Access Compliance Report Public Rights-of-Way (Curb Ramps)

Main Street: ST MAYS		Cross Street: TUBEROSE_ST		Location:	SE
ADA ID: RPRK211103143154	Ramp Type: Type 4 - Parallel	Initial Pass/Fail: Fail	Overall Compliance: No	Severity Score:	2
Codes/Mitigation Info/Possible Solution			Field Measurements/Component Compliance

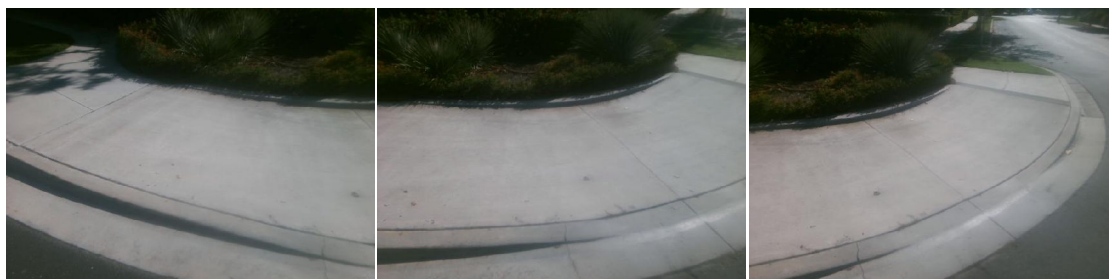
Compliance	Description	Data	Compliance	Description	Data
N/A	Ramp Length LT (in)	132	N/A	Ramp Length RT (in)	137
Yes	Ramp Width LT (in)	88	Yes	Ramp Width RT (in)	88
Yes	Ramp Run Slope LT (%)	4.2	Yes	Ramp Run Slope RT (%)	5.8
No	Ramp Cross Slope LT (%)	3.6	No	Ramp Cross Slope RT (%)	3.5
N/A	Landing Present	N/A	N/A	DWS Provided	N/A
N/A	Landing Length (in)	N/A	N/A	DWS Contrast	N/A
N/A	Landing Width (in)	N/A	N/A	DWS Length (in)	N/A
N/A	Landing Run Slope (%)	N/A	N/A	DWS Full Width	N/A
N/A	Landing Cross Slope (%)	N/A		DWS Offset Type	N/A
N/A	Landing Movement Obstructed?	N/A	N/A	DWS Offset Left (in)	N/A
	Landing Movement Type	N/A	N/A	DWS Offset Right (in)	N/A
N/A	Landing Shared	N/A			
N/A	Clear Space	Yes			
N/A	Clear Space To Crosswalk (in)	N/A			
N/A	Marked Crosswalk 1	No	N/A	Marked Crosswalk 2	No
	Crossing 1 Direction	N		Crossing 2 Direction	W
	Marked Crosswalk 1 Width (in)	N/A		Marked Crosswalk 2 Width (in)	N/A

Remove & Replace Curb Ramp With Two New Directional Ramps or Equivalent.
